UNITED STATES
NUCLEAR REGULATORY COMMISSION
WASHINGTON, D. C. 20555

APPLICANT: Public Service Electric & Gas Company (PSE&G)
FACILITY: Hope Creek Generating Station
SUBJECT: SUMMARY OF STRUCTURAL AND GEOTECHNICAL ENGINEERING
BRANCH (SGEB) MEETING

On August 1, 1984, a meeting was held in the Bethesda, Maryland offices of the NRC to discuss the remaining SGEB-Structural audit open items identified in the Draft SER. A list of meeting attendees is included as Enclosure 1 to this meeting summary.

FIGURE A-13-23

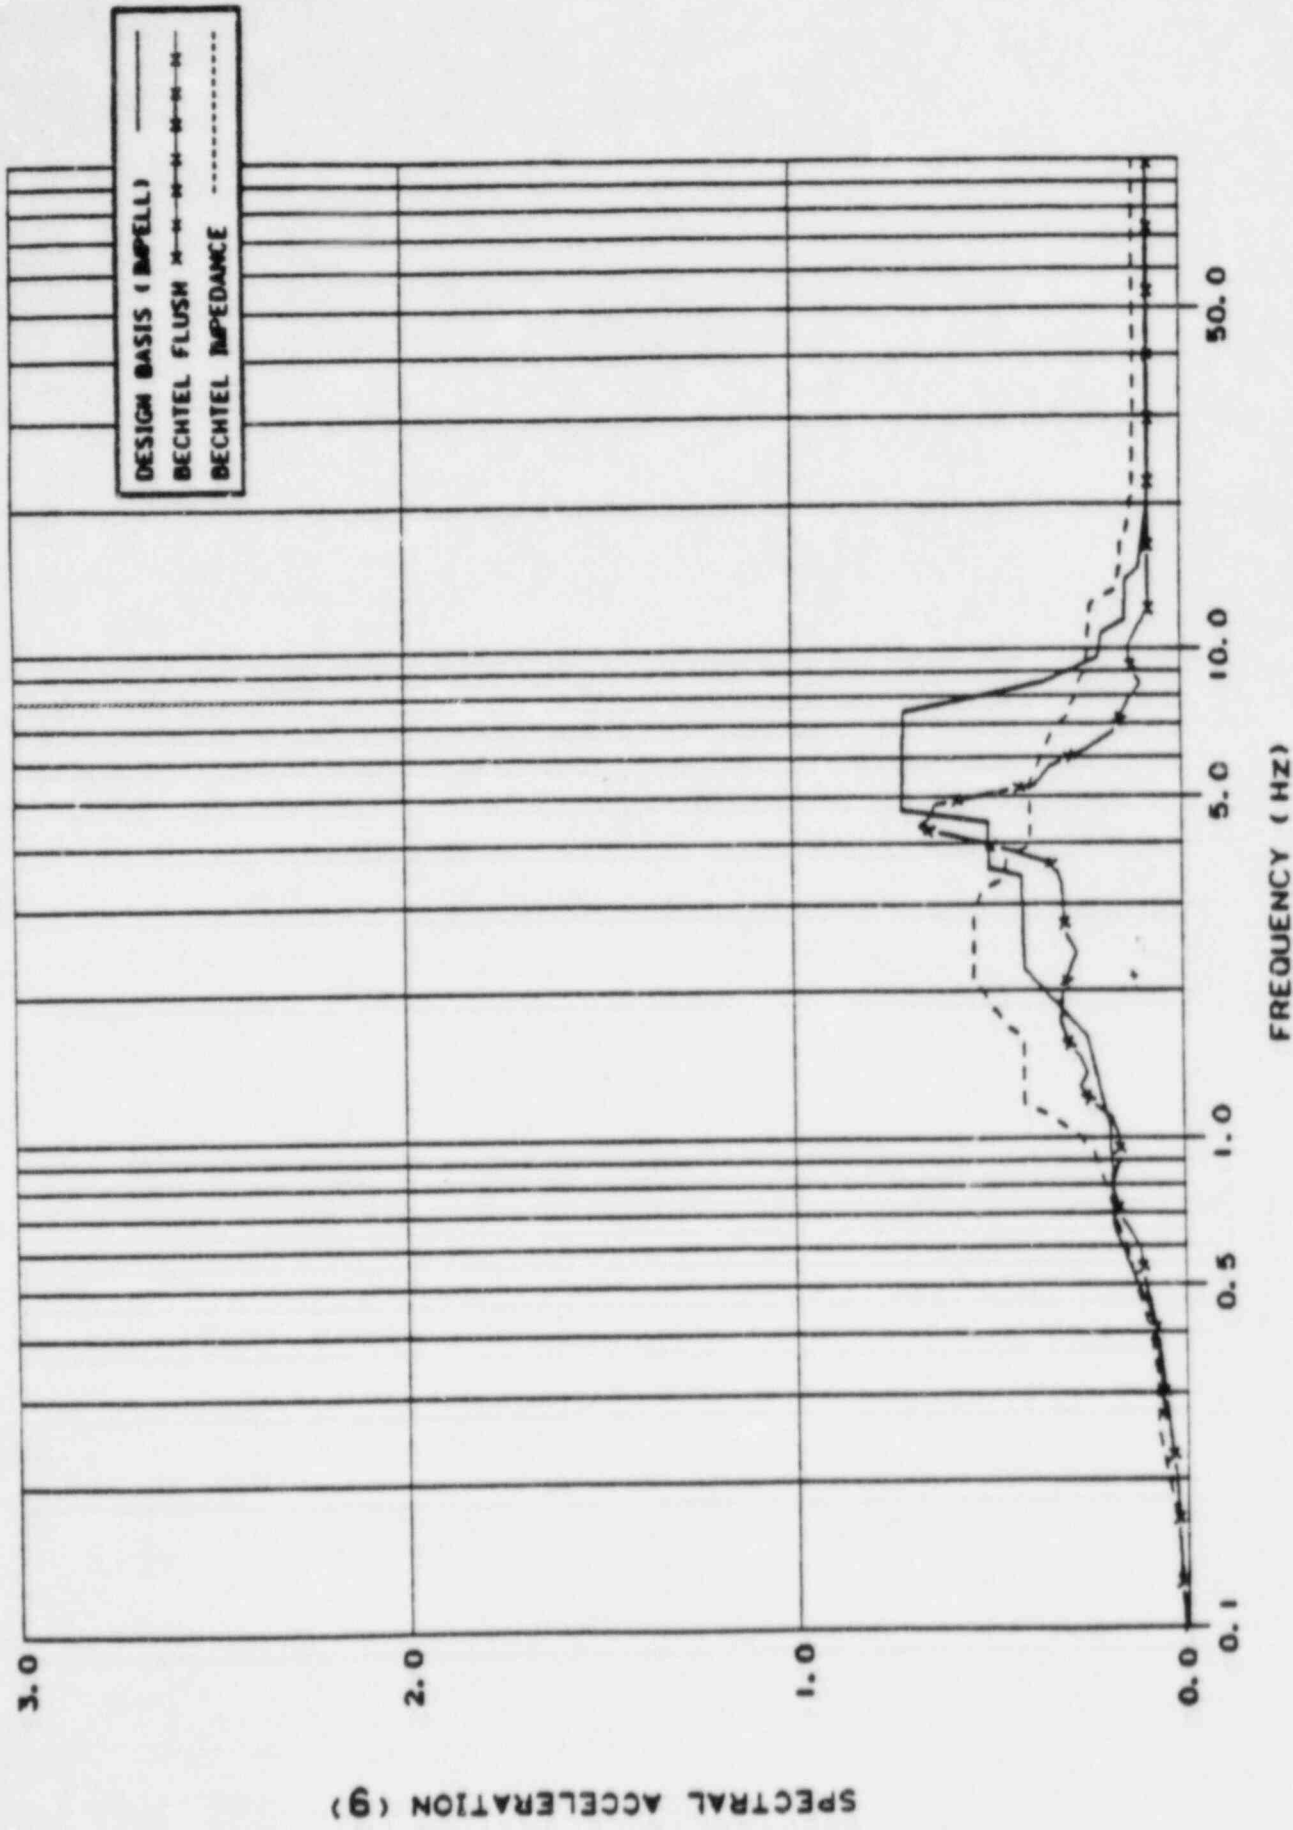
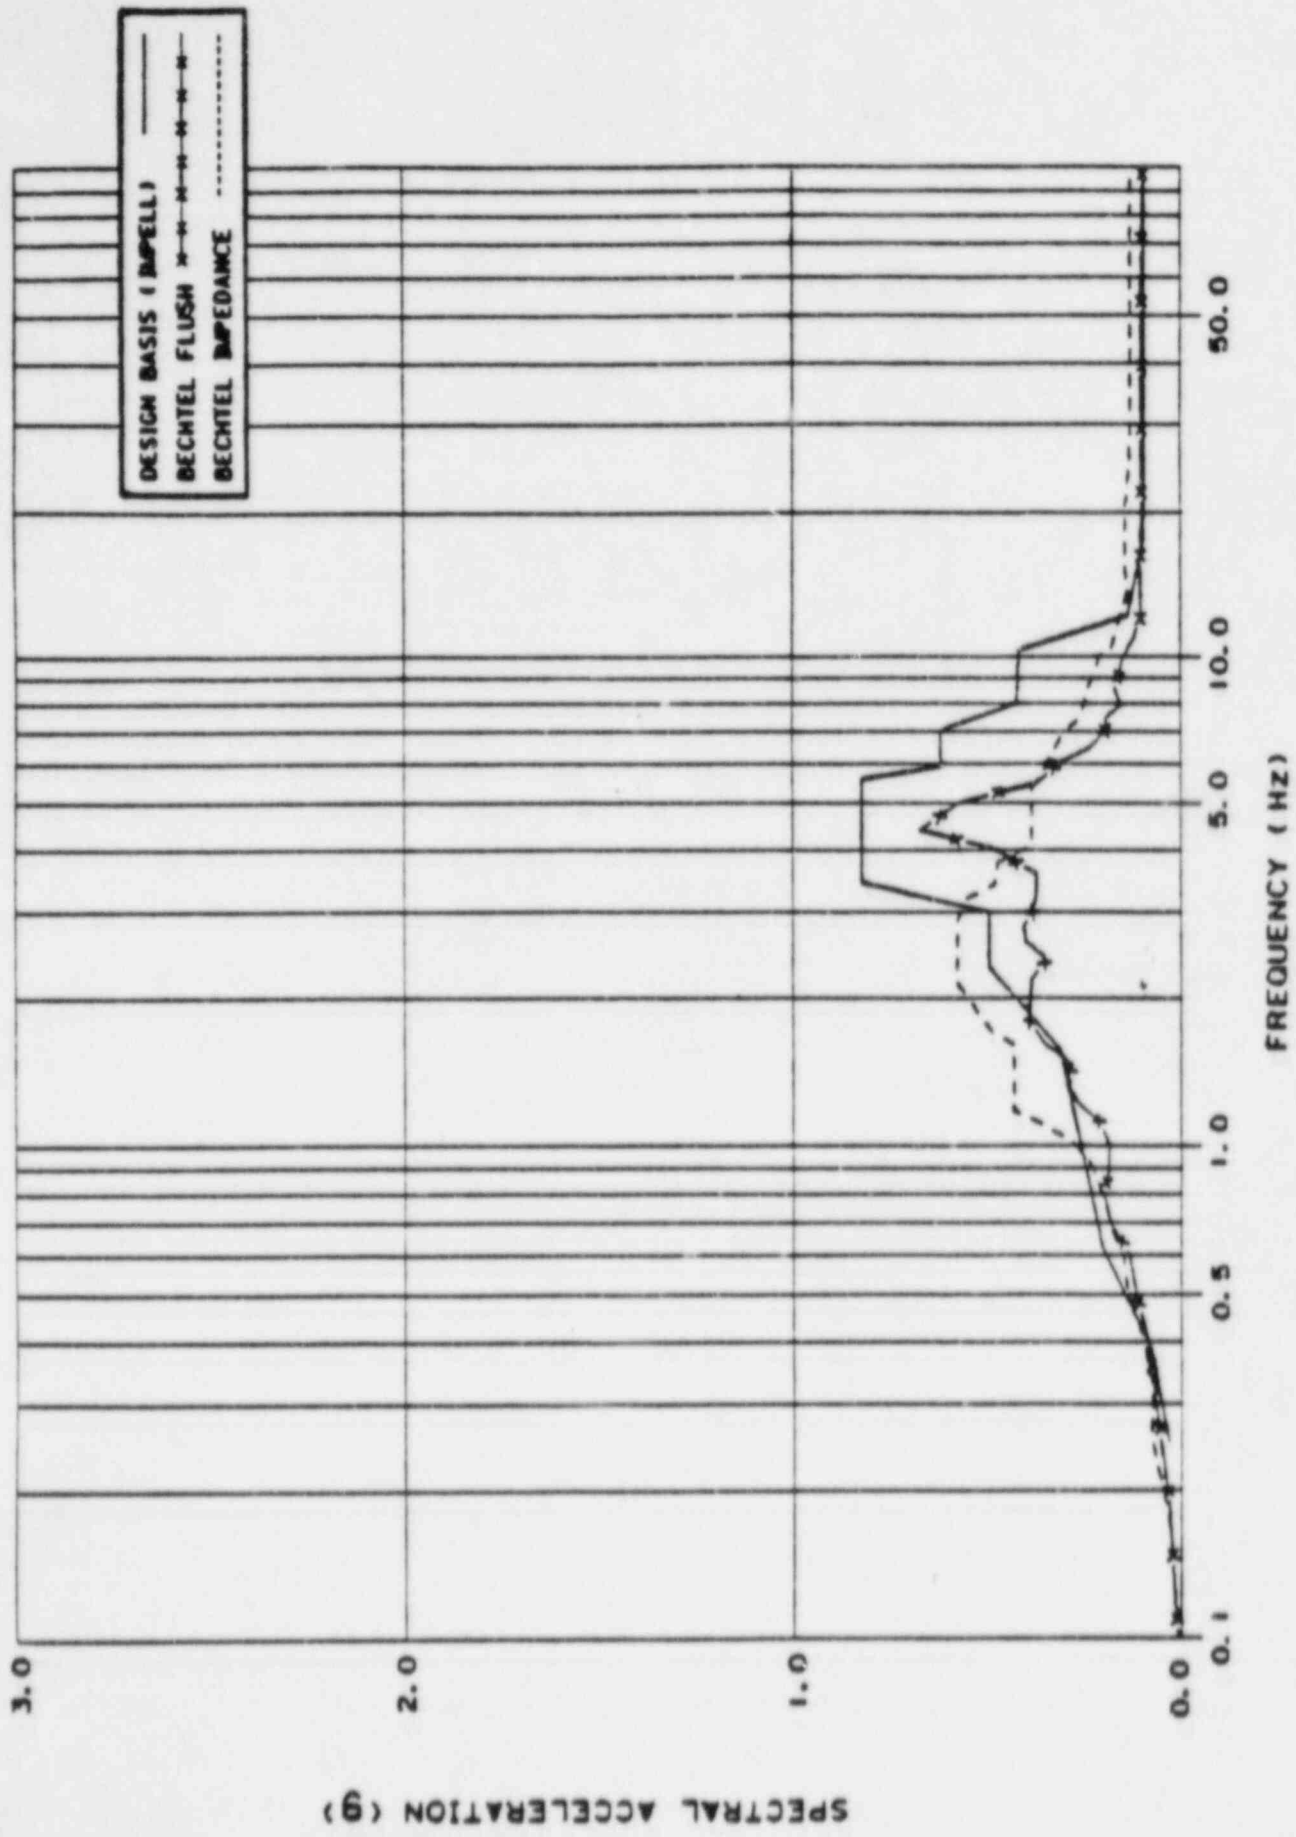
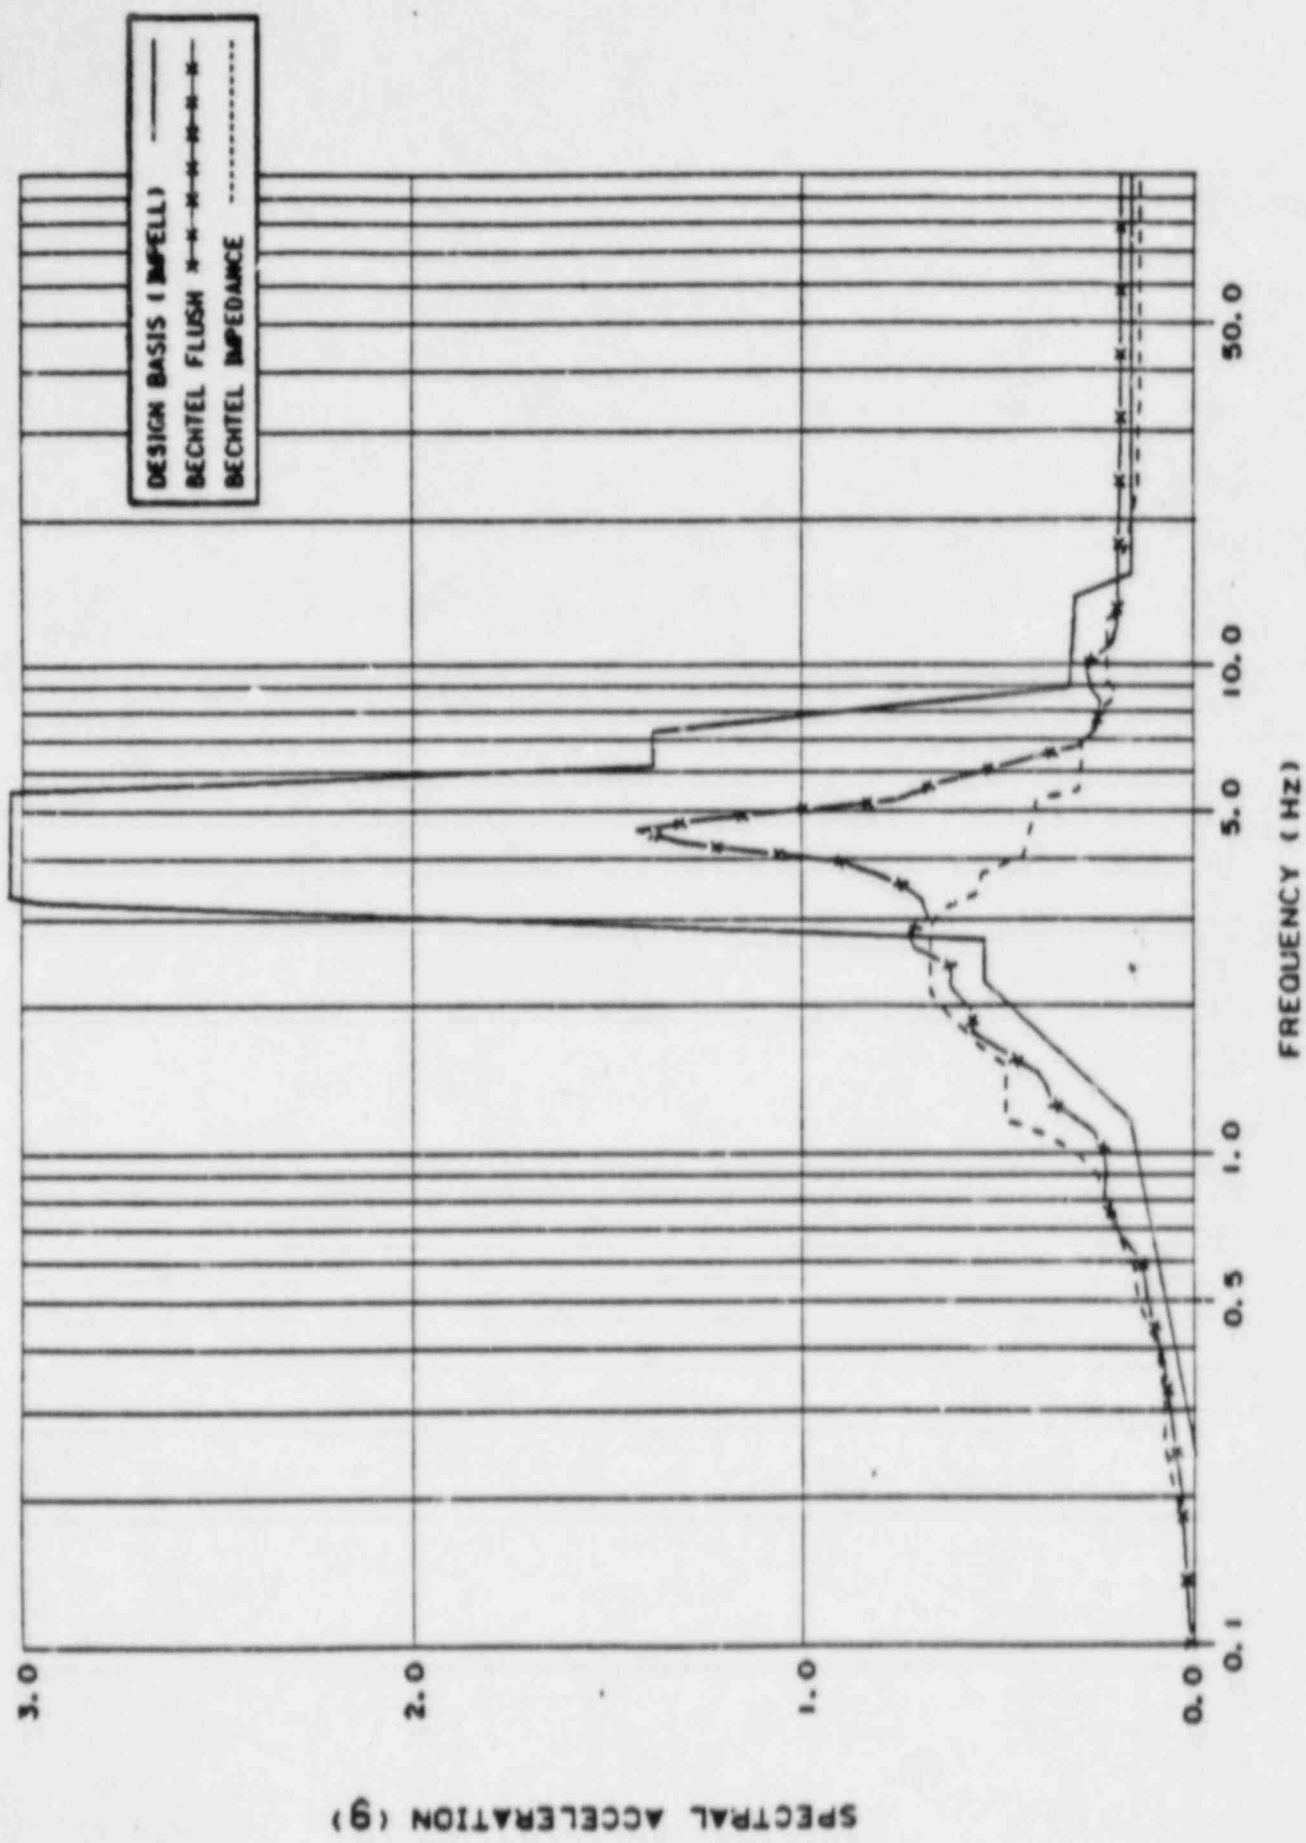
Question: Provide comparison of Bechtel Independent Verification Results with the Design Basis Results.

Figures A-13-2 to A-13-37 show the comparison of the response spectra (2% damping) obtained from the above three seismic soil-structure interaction analyses. Discussions of these comparisons are as follows:

Bechtel's independent soil-structure interaction analyses are performed using the computer code FLUSH. The results of independent finite element analyses are in reasonable agreement with those of the design basis analyses. As can be seen from Figures A-13-2 through A-13-37, the horizontal response spectra obtained from the independent finite element analyses are generally enveloped by those obtained from the design basis analyses except for the frequency range lower than 2 Hz. The vertical response spectra showed some exceedances at the frequency range of 18 Hz. These exceedances are listed in Table A-13-1.

The peak spectral accelerations obtained from the impedance approach analyses are generally lower than those obtained from the design basis analyses. However, these response spectra are not completely enveloped by those obtained from the design basis analysis, especially in the frequency range between 1.0 and 3.5 Hz. Also, there are some local exceedances in the higher frequency range, as shown in Figures A-13-2 through A-13-37.
